Crown Wears (Pvt.) Ltd. (Extension)

Jamirdia, Masterbari, Bhaluka, Mymensingh.
(24.300775, 90.384717)
04 and 20 March 2025

Observation-01: High stress in the foundation exceeds the normal design limit. [Building-5]

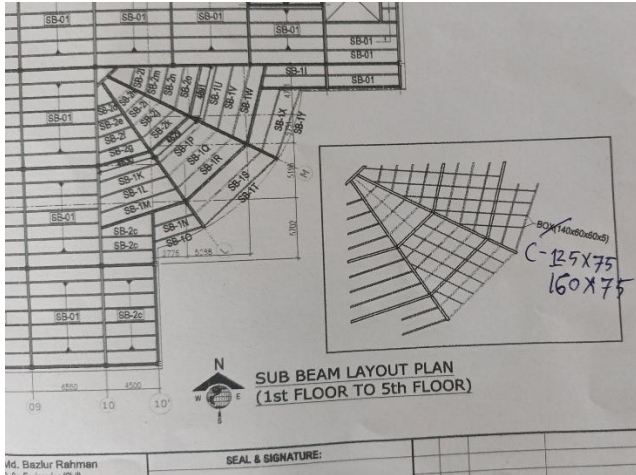
Description: The cursory calculation indicates that foundations are highly stressed above the normal design limit at the March locations considering the observed live load of 3 kPa for the typical production area & 6 kPa for the store area, design strength of concrete & re-bar and bearing capacity from the provided geotechnical investigation report.

The building engineer to review the design, loads and column stresses in the area identified above. A detailed engineering Assessment of the Factory is to be commenced. Produce and actively manage a loading plan for all floor plates within the factory considering floor capacity and foundation capacity. Detail Engineering Assessment to be completed. Continue implementing the load plan.

Observation-02: Lack of information and discrepancy between the provided drawing and site condition. [Building-5]

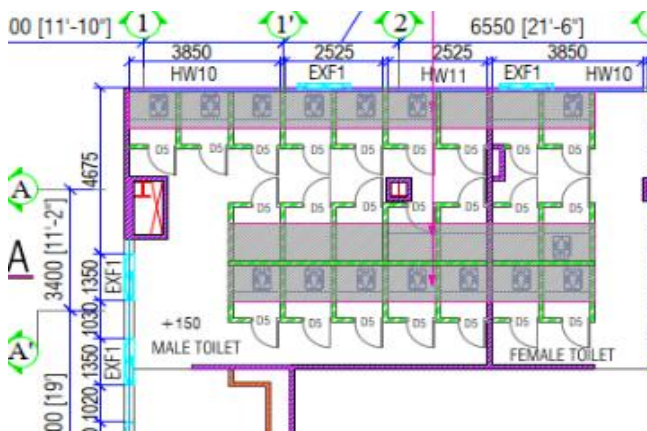
Sub-beam sections and sizes do not match the provided drawing

Additional floor raises were found in the toilet zone which were not mentioned in the drawing.

Description: During the inspection, discrepancies and lack of information were observed between the provided drawing and on-site conditions. The building engineer is required to survey the whole structure and update the drawing reflecting actual on-site condition.

6.	Lack of information and discrepancy between the provided drawing and site condition. [Building-5]	The building engineer is required to survey the whole structure and update the drawing reflecting actual on-site condition.	within 6 weeks

Observation-03: Lack of height Marking in the storage area. [Building-5]

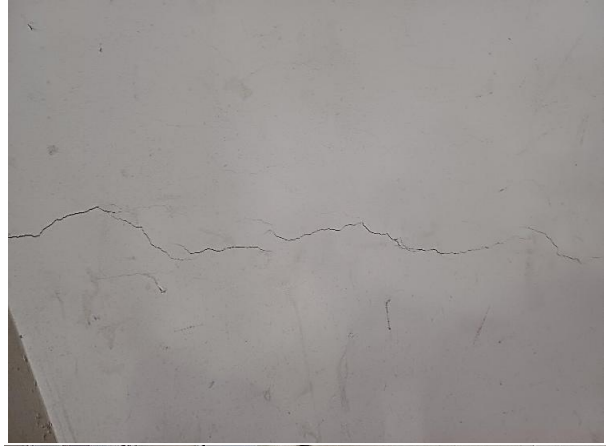
Description: Load restriction height Marking was not provided in the storage areas. The factory is required to provide load restriction height Marking in the storage areas as per the floor loading capacity and compliance requirement.

7.	Lack of height Marking in the storage area. [Building-5]	The factory is required to provide load restriction height Marking in the storage areas as per the floor loading capacity and compliance requirement.	within 6 weeks

Observation 11: Construction debris on the 2nd floor (existing roof). (Building – 6)

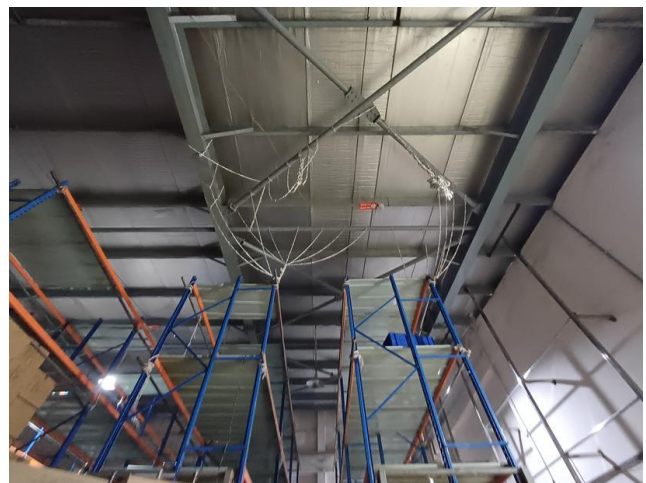
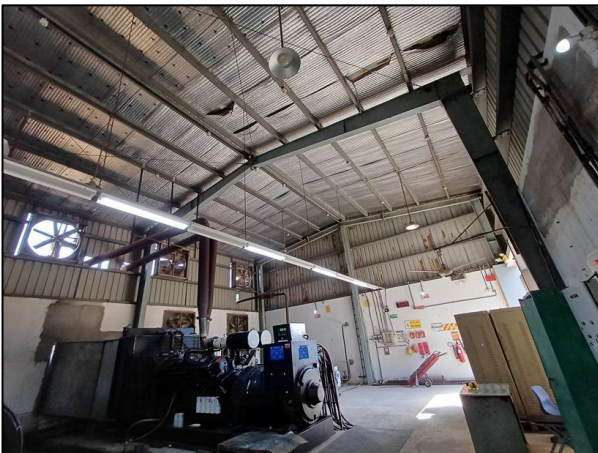
Description: Construction debris was found on the 2nd floor. The building engineer is required to remove the construction debris.

17.	Construction debris on the 2nd floor (existing roof). (Building – 6)	The building engineer is required to remove the construction debris.	within 6 weeks
